Access Compliance Report

Public Rights-of-Way

(Curb Ramps)

Intersection ID: 10041704	Main Street: WILD_ELM_RD	Cross Street: N/A	Location:	N
ADA ID: BB8B5EFFB916	Ramp Type: Perp	Initial Pass/Fail: Fail	Overall Compliance: No	Severity Score: 13.75
Codes/Mitigation Info/Possible Solution		Field Measurements/Component Compliance

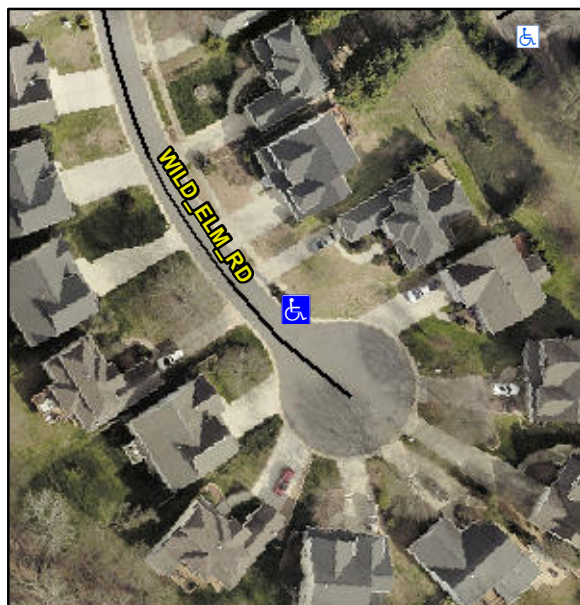
Remove & Replace Entire Ramp.

R304.2.2

Compliance	Description	Data	Compliance	Description	Data
N/A	Ramp Length (in)	46.0	No	Ramp Slope (%)	10.2
Yes	Ramp Width (in)	48.0	Yes	Ramp XSlope (%)	4.0
N/A	Flare Type LT	N/A	N/A	Flare Type RT	N/A
N/A	Flare Slope LT (%)	N/A	N/A	Flare Slope RT (%)	N/A
N/A	Flare Traversable LT?	N/A	N/A	Flare Traversable RT?	N/A
N/A	Landing Length (in)	N/A	N/A	DWS Provided?	N/A
N/A	Landing Width (in)	N/A	N/A	DWS Contrast?	N/A
N/A	Landing Slope (%)	N/A	N/A	DWS Length (in)	N/A
N/A	Landing X Slope (%)	N/A	N/A	DWS Full Width?	N/A
N/A	Landing Curb? (Y/N)	N/A	N/A	DWS Offset (in)	N/A
N/A	Shared Landing?	N/A			
N/A	Gutter Ponding?	N/A	N/A	Gutter Slope (%)	N/A
N/A	Gutter Lip Ht (in)	N/A	N/A	Gutter X Slope (%)	N/A
N/A	Painted X Walk1?	No	N/A	Painted X Walk2?	N/A
	X Walk 1 Direction	To SW		X Walk 2 Direction	N/A
N/A	X Walk 1 Width (in)	N/A	N/A	X Walk 2 Width (in)	N/A
	X Walk 1 Slope (%)	4.5		X Walk 2 Slope (%)	N/A
	X Walk 1 X Slope (%)	6.1		X Walk 2 X Slope (%)	N/A
